**SOLICITATION AMENDMENT
MODIFICATION DE L'INVITATION**

Title - Sujet Quick Response Support Vehicle Camion d'appui d'intervention rapide	
Solicitation No. - N° de l'invitation M9062-223073/A	Amendment No. - N° modif. 001
Client Reference No. - N° de référence du client M9062-223073	Date 2022-02-11
GETS Reference No. - N° de référence de SEAG PW-\$\$\$HP-927-80820	
File No. - N° de dossier hp927.M9062-223073	CCC No./N° CCC - FMS No./N° VME
Solicitation Closes - L'invitation prend fin at - à 02:00 PM Eastern Standard Time EST on - le 2022-03-02 Heure Normale du l'Est HNE	
F.O.B. - F.A.B. Plant-Usine: <input type="checkbox"/> Destination: <input type="checkbox"/> Other-Autre: <input type="checkbox"/>	
Address Enquiries to: - Adresser toutes questions à: Takam(hp927), Maurice	Buyer Id - Id de l'acheteur hp927
Telephone No. - N° de téléphone (613) 297-3516 ()	FAX No. - N° de FAX () -
Destination - of Goods, Services, and Construction: Destination - des biens, services et construction:

AMENDMENT 001

extend the solicitation closing date;
answer bidders' questions; and
revise Annex "B" - Mandatory Requirements

Left Side View (not to scale)

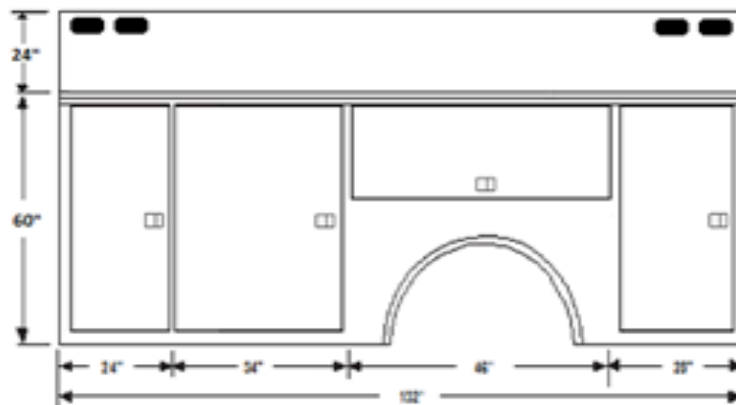
Overall exterior body dimensions –

The maximum length of the body excluding the rear bumper is stated as 134" however sections 9-12 starting on page 31 of 40 specify a specific dimension for each of the 4 compartments. The total sum of those compartments is 132". This does not allow for spacing between compartments and the necessary front and rear wall thicknesses.

In order to meet all the compartment widths specified we require an increase the length of the body to 144". If not than some compartments would have to be made narrower to meet the maximum length.

The requirement has not requested spacing between the compartments in sections 9 to 12 & 31 to 40.
